**SUBMITTAL TO THE BOARD OF SUPERVISORS  
COUNTY OF RIVERSIDE, STATE OF CALIFORNIA**

**SUBJECT:** DEPARTMENT OF WASTE RESOURCES: Contract Change Order No.1 for the Construction of Daily Cover Excavation and On-Call Site Improvements at Badlands and Lamb Canyon Sanitary Landfills, District 5 [\$921,740 –Department of Waste Resources Enterprise Funds] (Nothing Further Required under CEQA)

**CONTRACT CHANGE ORDER NO. 1**

Repair Work Item NO.2

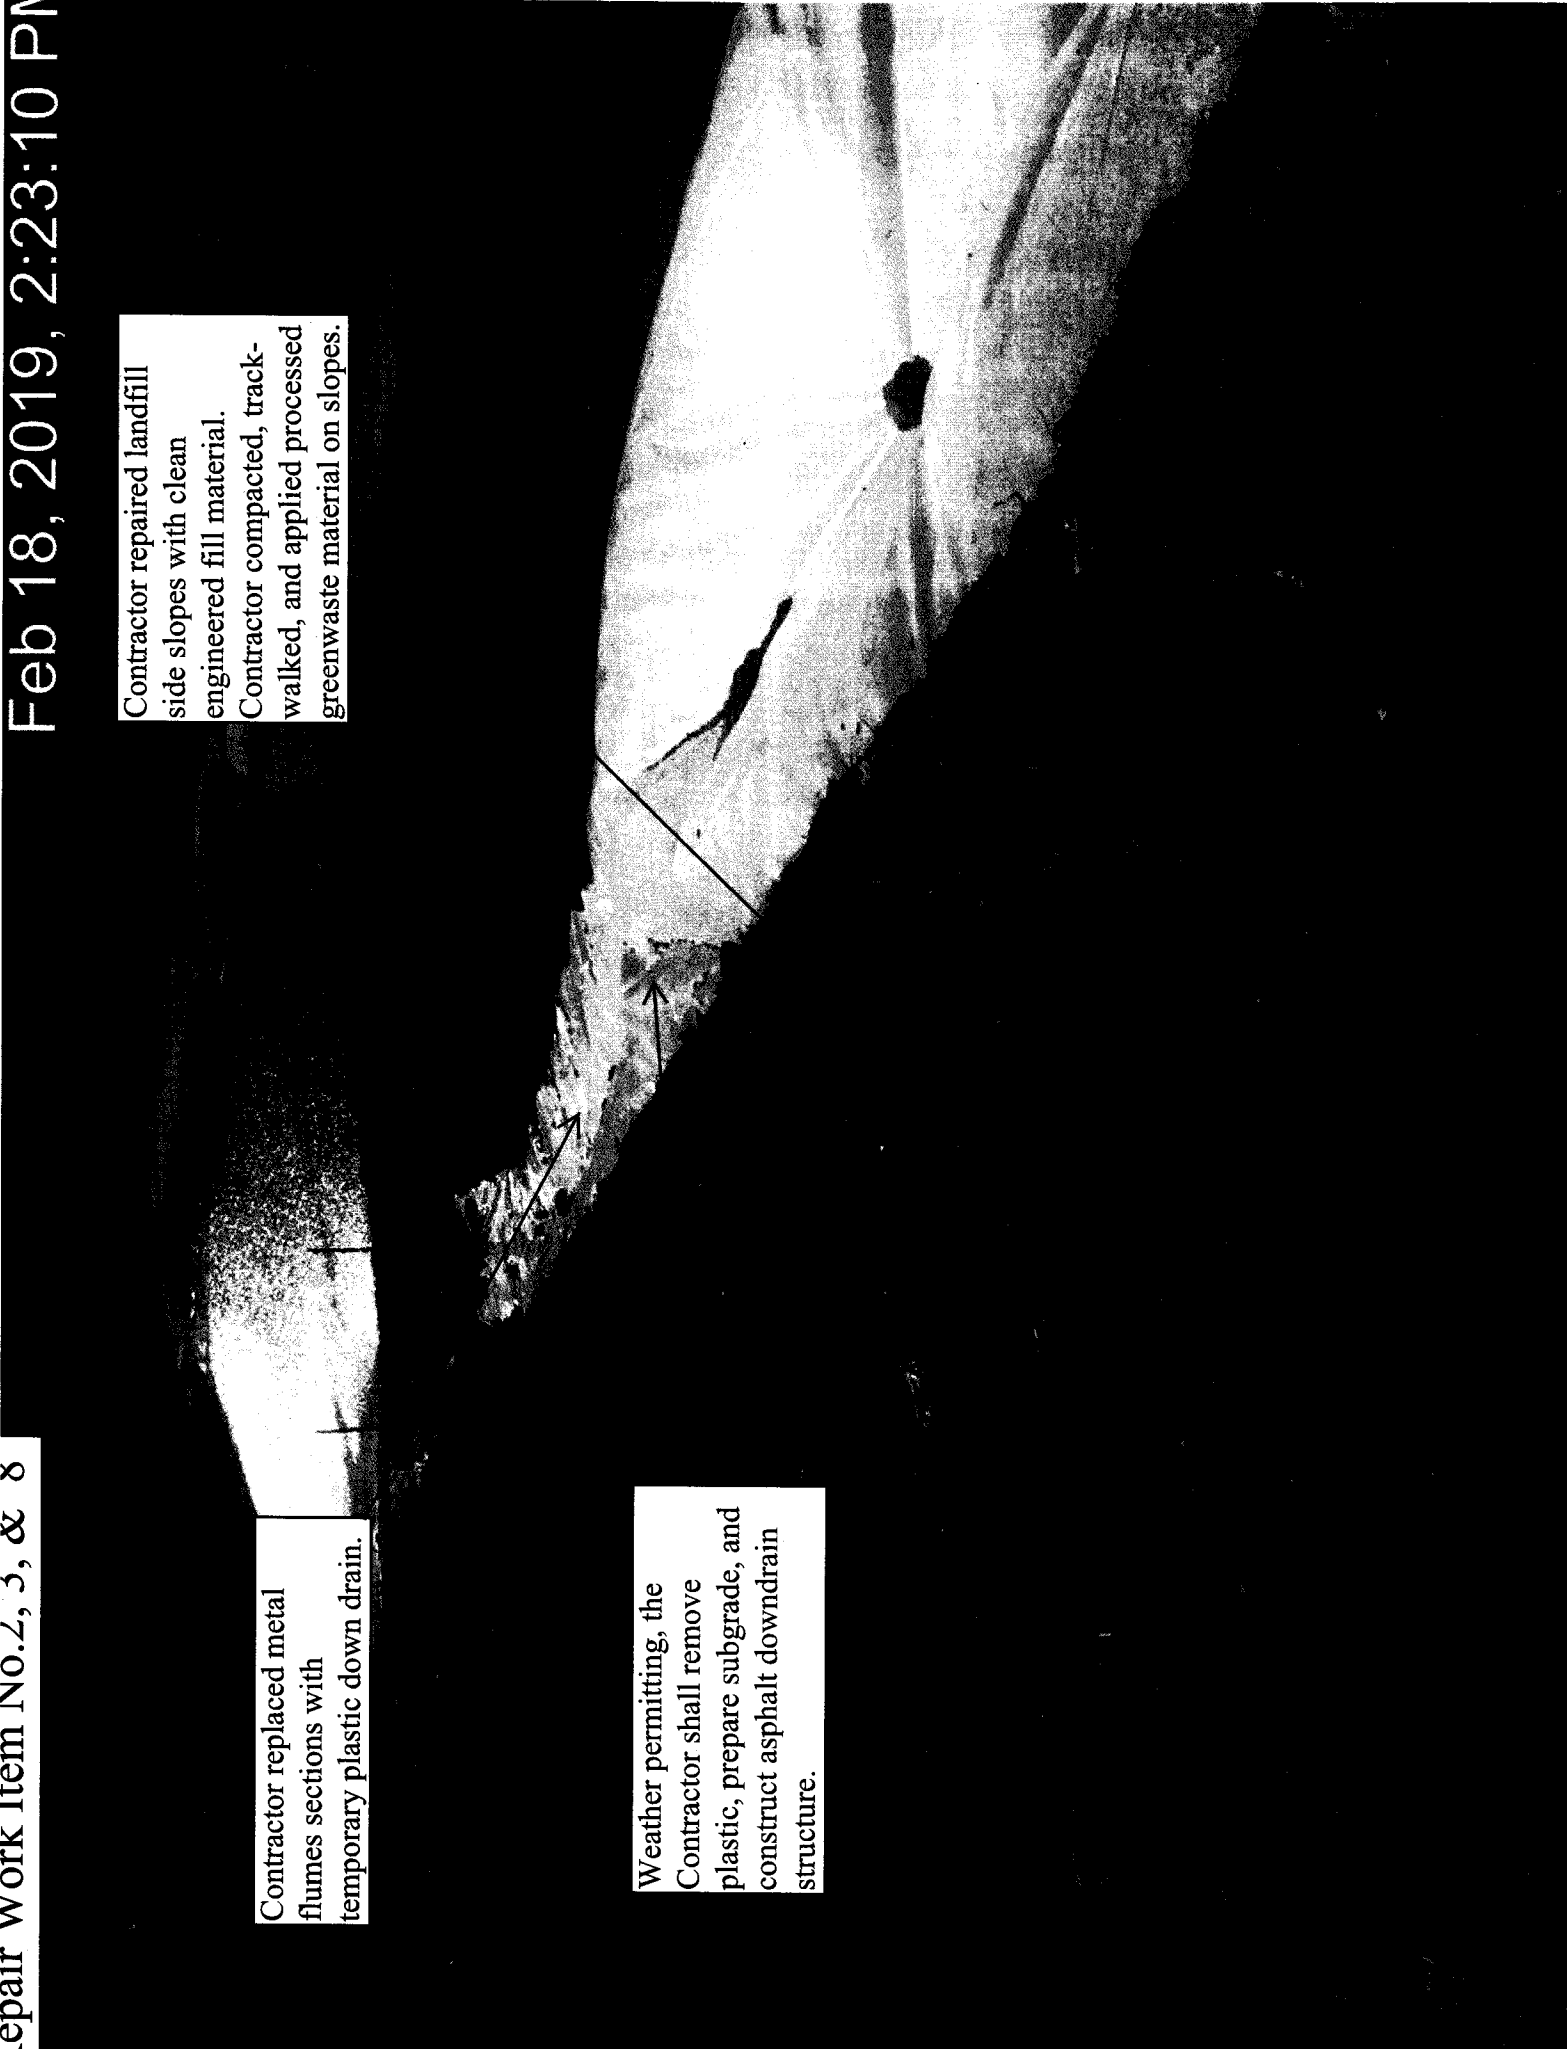
Repair landfill side slopes with clean engineered fill material. Compact, track-walk, and apply processed greenwaste material on slopes.

Remove metal flumes sections and replace with temporary plastic down drain.

Weather permitting, the Contractor shall remove plastic, prepare subgrade, and construct asphalt down drain structure.

Contractor replaced metal flumes sections with temporary plastic down drain.

Contractor repaired landfill side slopes with clean engineered fill material. Contractor compacted, tracked, walked, and applied processed greenwaste material on slopes.

## Repair Work Item No.4

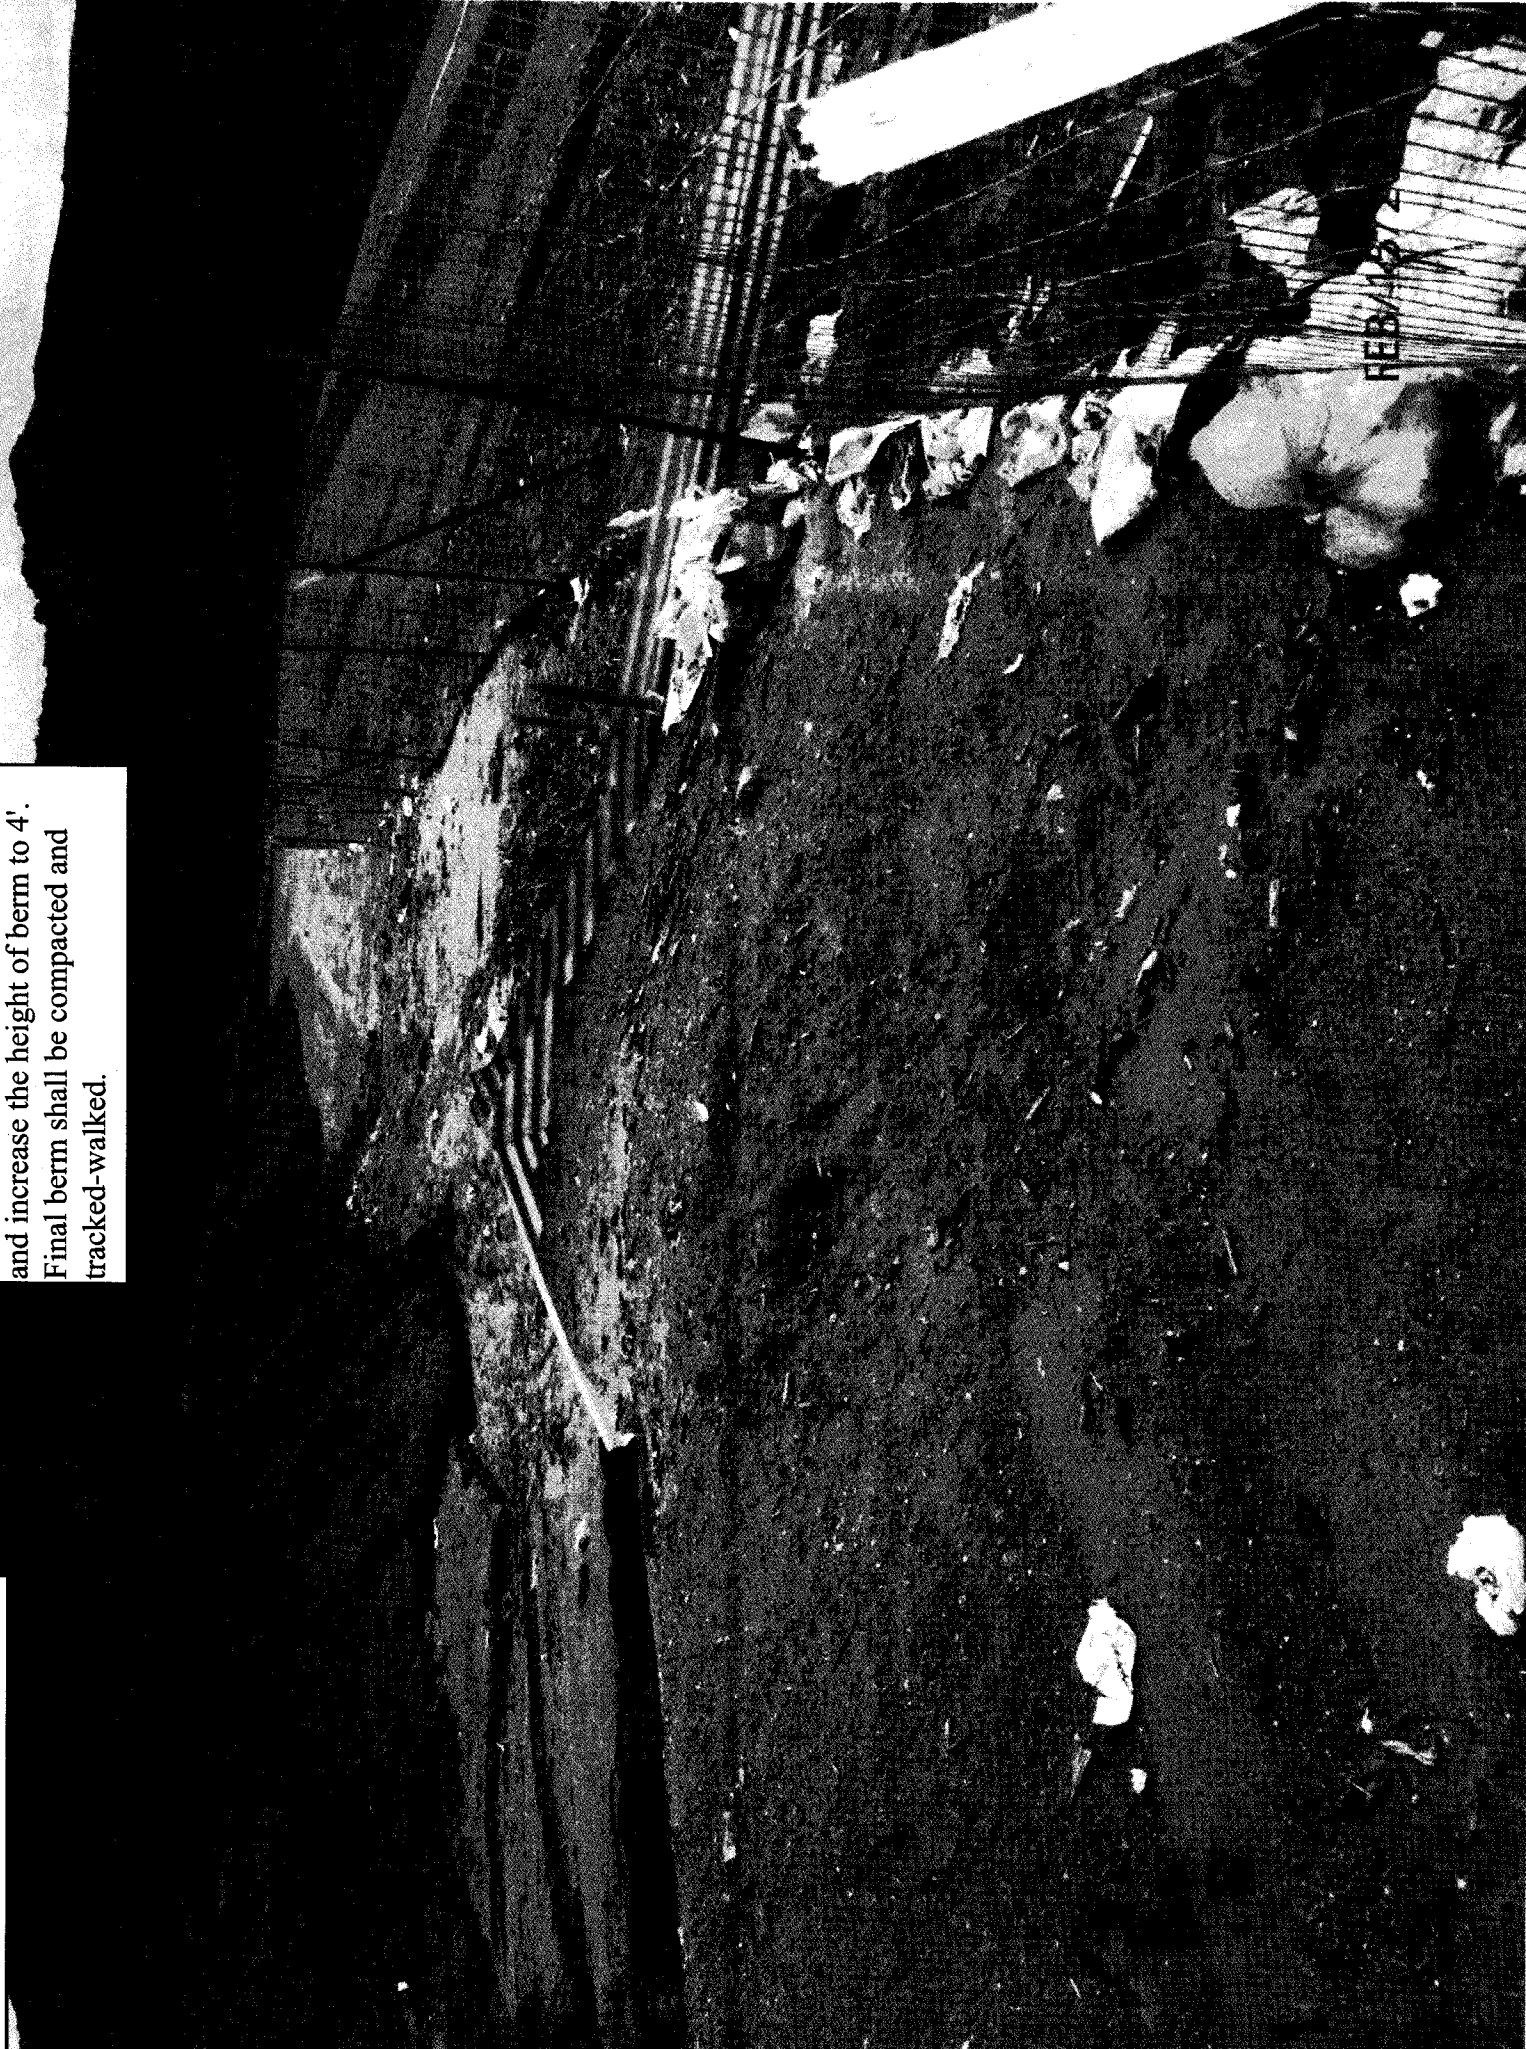
Repair damage earthen diversion berm and increase the height of berm to 4'. Final berm shall be compacted and tracked-walked.

# Repair Work Item No.9

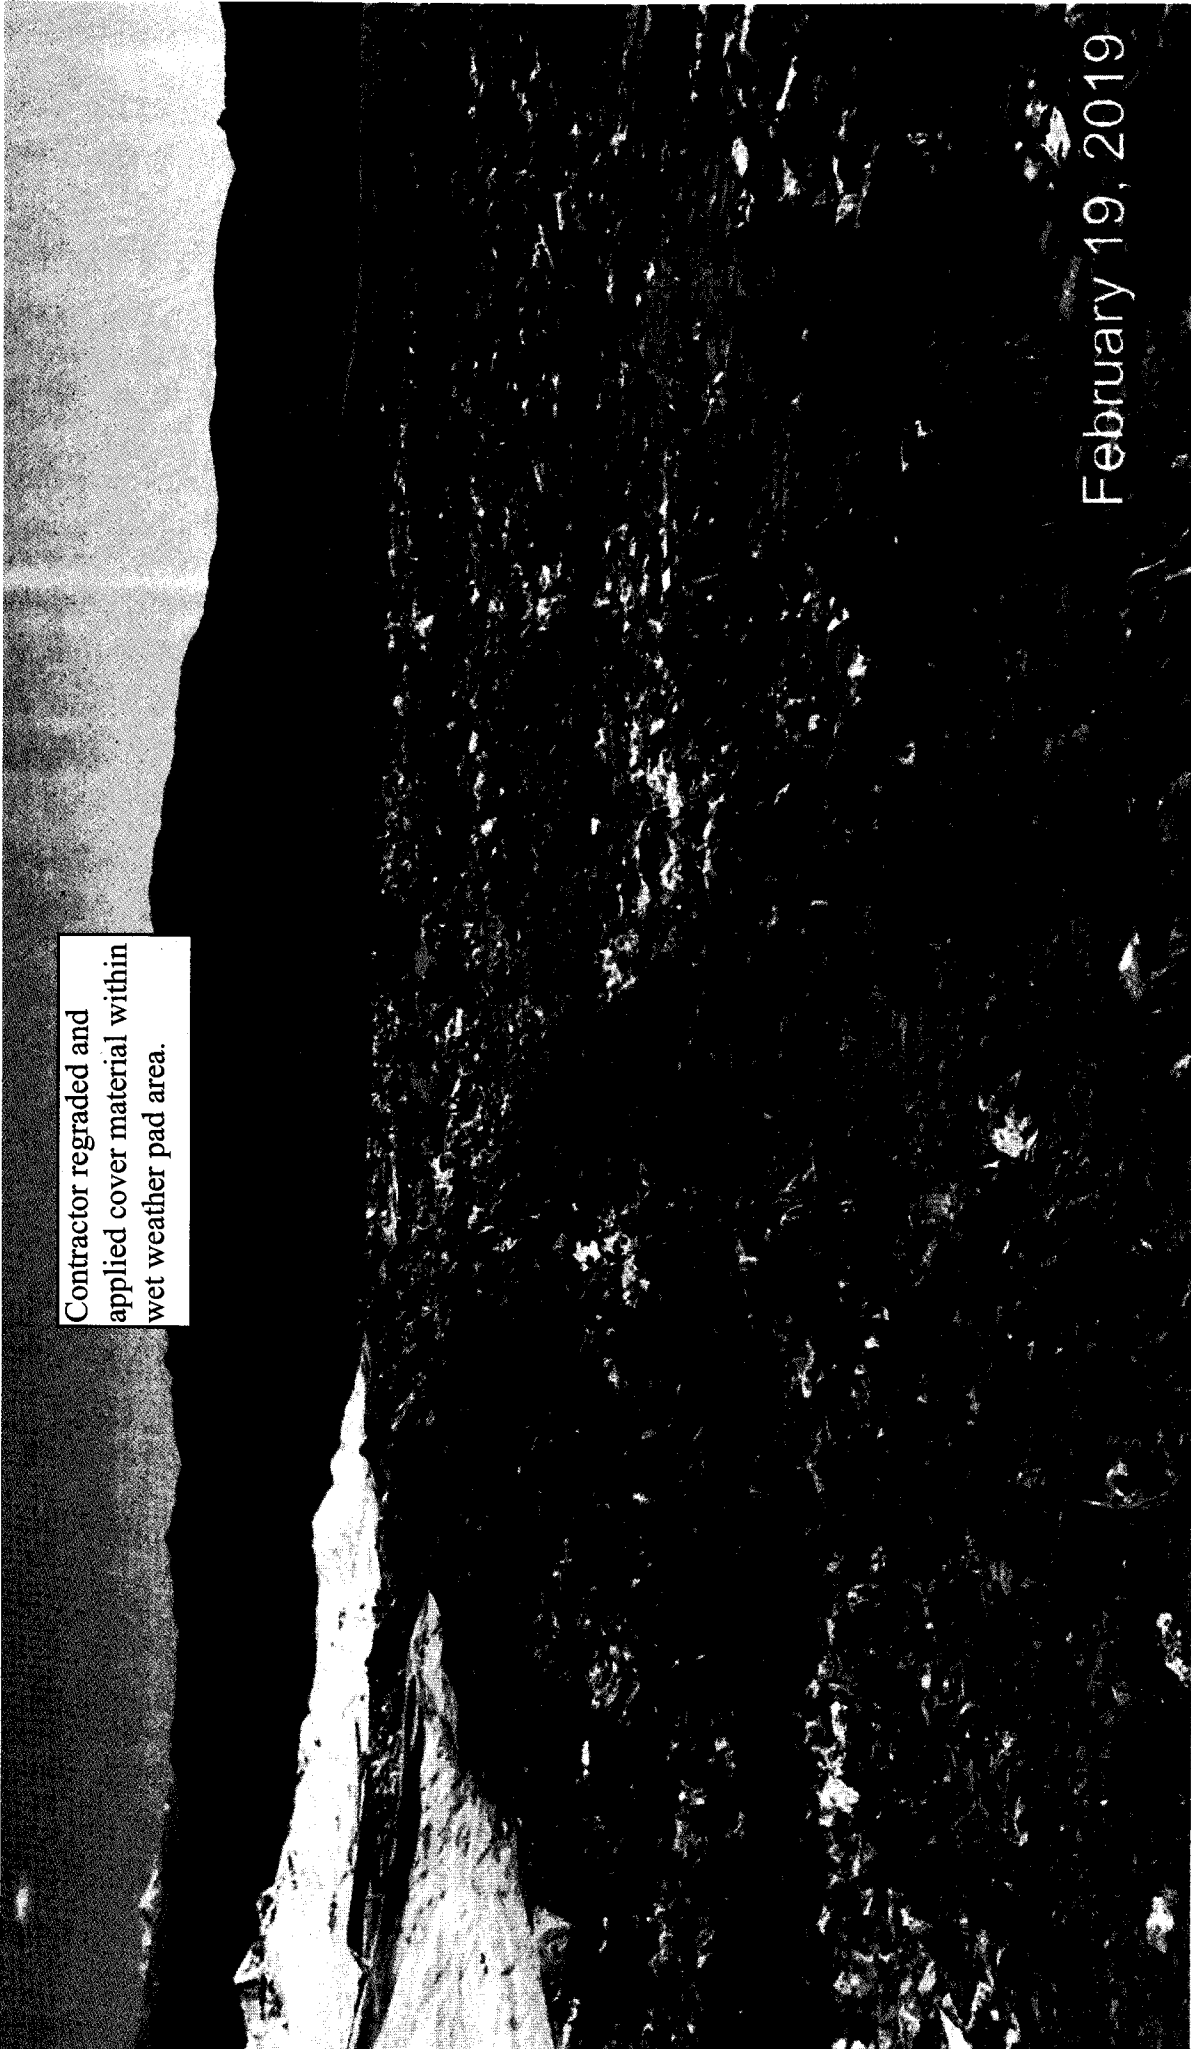
- b) Over-excavate side slope and replace with engineered fill compacted at 95% R.C.
- b) Install geogrid reinforcement at ~ 4-ft vertical interval within the engineered fill layer.
- c) Place partially grouted rip-rap.
